APPLICATION NO.	FILING DATE	FIRST NAMED INVENTOR	ATTORNEY DOCKET NO.	CONFIRMATION NO.
10/668,734	09/23/2003	John J. Toben	6006-141-1	2477
7590 Nicholas J. Tuccillo, Esq. McCormick, Paulding & Huber LLP CityPlace II 185 Asylum Street Hartford, CT 06103			EXAMINER GARCIA, ERNESTO	
			ART UNIT 3679	PAPER NUMBER
SHORTENED STATUTORY PERIOD OF RESPONSE		MAIL DATE	DELIVERY MODE	
3 MONTHS		02/16/2007	PAPER

Office Action Summary	Application No.	Applicant(s)	
	10/668,734	TOBEN ET AL.	
	Examiner	Art Unit	
	Ernesto Garcia	3679

DETAILED ACTION

Fig. 12.

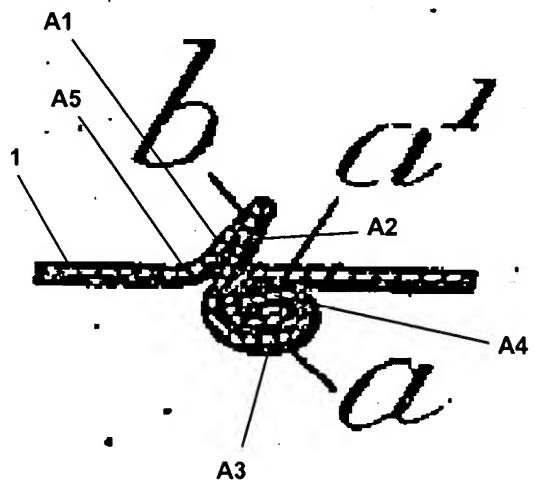
Regarding claim 20, James discloses, in Figure 12, a method comprising:
integrally forming a female end portion **a** at another distal end of a duct wall **B1** (see marked-up attachment); and,
integrally forming the female end portion includes:
bending a first fold **A1** beginning at a break point **A5** of the duct wall **B1** to extend at a hemmed angle **B2** towards an interior of a ductwork;
bending a second fold **A2** back upon the first fold **A1** to extend substantially adjacent to the break point **A5**;
bending a third fold **A3** beginning substantially adjacent to the break point **A5** and extending substantially parallel to the duct wall **B1**; and,
bending a fourth fold **A4** back against the third bold **A3**.
